APPENDIX E – APPLICANT’S RESPONSE TO COUNCILLOR SUBMISSION

Response to Planning Report prepared by Moody & Doyle

Development:
Subdivision at West Wallsend

Applicant:
Hammersmith Management

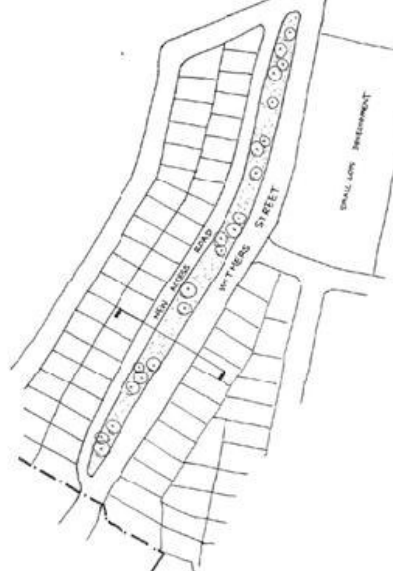
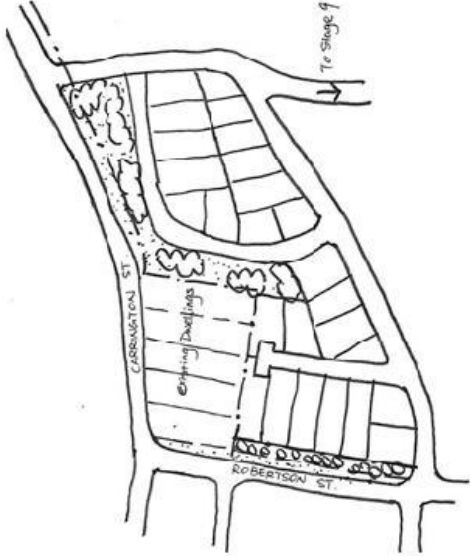
4.2.6 Detention Basins The proposed detention basin at the entrance to Withers Street on its southern side is of concern. Whilst I acknowledge that there will be landscaping provided in conjunction with the proposed detention basins, have a concern that the proposed detention basin will limit the ability to satisfactorily maintain the bushland setting.	Brown Consulting, who designed the basins, have made the following comments in regard to this issue (refer to Attachment C): <i>The provision of onsite detention is required for the site to meet Councils DOPs and Engineering guidelines. The basins not only serve to detain flows for stormwater quantity management, but also integrate</i>

Planning Report Comments	Responses
	<i>Detention filtration of flows to treat stormwater quality to a level that is required in Councils Water Cycle Management Guidelines.</i> Muir Landscape Architecture provided an additional comment in relation to this issue (refer to Attachment A). Maintaining the bushland setting is achieved by retaining 45% of the site under natural vegetation. The stormwater assessment prepared in support of the subdivision proposal found that the detention basins will reduce existing flooding problems. Detention basins are provided because of their proven environmental benefits and they are a mandatory Council requirement. The basins are a mandatory requirement of Council and represent current best practice. The presence of basins will not have an adverse effect on character of West Walsend. Adequate detail has been provided including landscaping details and sections of the proposed works. The basins will have the appearance of open space/ natural areas. Generally the visual impacts of basins are positive and lots adjoining or having views of basin areas are often highly sought after. Muir Landscape Architecture provided the following comment in relation to this issue (refer to Attachment A): <i>The Planning Report claims 'the detention basins will reduce opportunities to provide trees'. To the contrary the detention basins will maximise opportunities for landscaping and tree planting.</i>
